Virginia Board of Housing and Community Development CODE AND STANDARDS COMMITTEE 2021 CODE CHANGE CYCLE – BOOK 2, PART 1 October 3, 2022

Opening Statement

Tab 2-USBC Proposals Recommended by Workgroups as Consensus for Approval

Figure R301.2(5)A ULTIMATE DESIGN WIND SPEEDS 8. Change Figure R301.2(5)B to read:

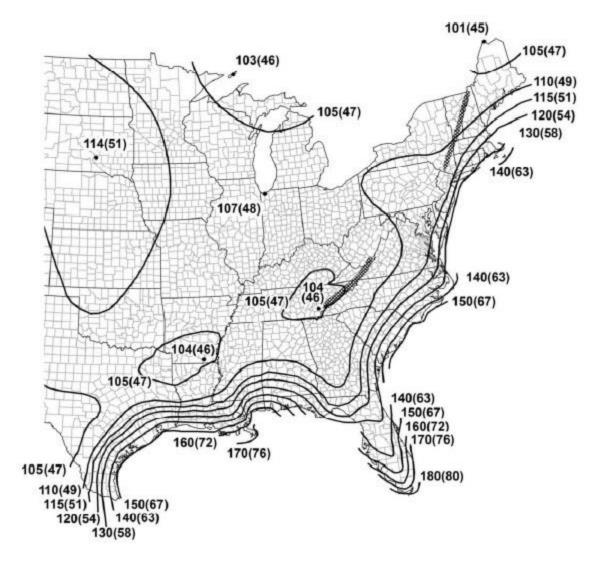
7. Change Figure R301.2(5)A to read:

Figure R301.2(8) COMPONENT AND CLADDING PRESSURE ZONES

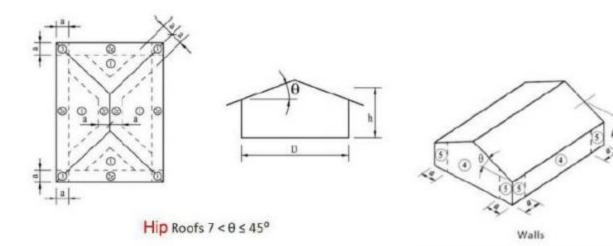
Figure R301.2(5)B REGIONS WHERE WIND DESIGN IS REQUIRED 9. Change Figure R301.2(8) to read:
